FINAL RECOMMENDATION OF THE EAST DESIGN REVIEW BOARD

Project Number: 3011923

Address: 418 Bellevue Ave E

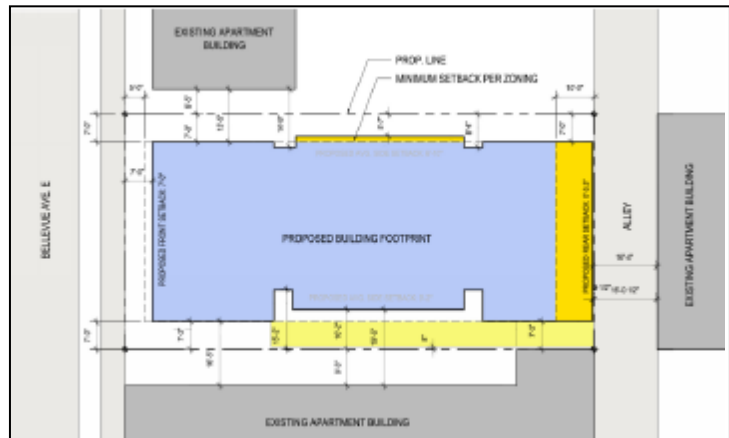
- 2. Setbacks (SMC 23.45.518 Table A):** The Code requires the following:

Rear Setback: 10' for rear lot line abutting an alley

Front Setback: 7' average, 5' minimum

Side Setback: For portions of the structure below 42 inches: 7' average, 5' minimum

For portions of the structure above 42 inches: 10' average, 7' minimum

Rear: At the EDG meeting, the Board supported the departure for encroachment into the rear setback given that this is the least sensitive side of the site. The proposed design is four inches from the rear property line. The Board recommended a condition regarding the quality of the garage doors facing the alley (see below). The Board voted unanimously in favor of the requested departure.

Front: At the EDG meeting, the Board was unanimously opposed to the proposed encroachment into the front setback. No departure from the front setback was proposed at the Recommendation meeting.

Sides: At the EDG meeting, the Board considered the proposed side

setbacks and agreed that portions of such encroachments might be acceptable depending on whether the ultimate design is responsive and sensitive towards the abutting neighbors and existing development pattern. On the north side, the proposed reduction in setback for the western half of the property (directly across from the neighboring building to the north) is not acceptable to the Board; however, the proposed encroachment on the eastern half of the north façade could be entertained as a departure. Similarly, on the south façade, the Board was opposed to the setback reduction for the western portion of this façade since it impacts the perception of the building width from Bellevue Ave. The Board would like to see a consistent minimum setback of five to seven feet along the south property line, however departing from the average might be acceptable depending on how the design is articulated and if it includes breaking up of the mass at the upper levels.

At the Recommendation meeting, the revised design responded directly to the guidance of the Board as follows and the Board voted unanimously in favor of each:

On the north side, the proposed setback is six feet, six inches average and five feet, seven inches minimum. The portion of the building directly across the neighboring building to the north, however, is a full seven feet. The portion of the proposed building that encroaches into the setback is across from the courtyard to the north and avoids the area closest to the adjacent building.

On the south side, the proposed building provides a seven foot, two inch setback and does not encroach into the side setback along the western portion of the site. Due to the site slope and provision of private open spaces for those units along the ground floor on the south side, the building projects into the side setback – see graphic below for details.

SMC 23.45.518)	Required	Proposed
Front setback from street lot line:	7' avg, 5' min.	7'-10" avg, 7'-8" min.
Side setback below 42" from grade:	7' avg, 5' min.	6'-6" avg, 5'-7" min. (north) 3'-9" avg, 0'-4" min (south facade @ L1)
Side setback above 42" from grade:	10' avg, 7' min.	6'-6" avg, 5'-7" min. (north) 9'-2" avg, 7'-2" min. (south @ levels 4-7)
Rear setback from alley lot line:	10' min.	0'-4" min.
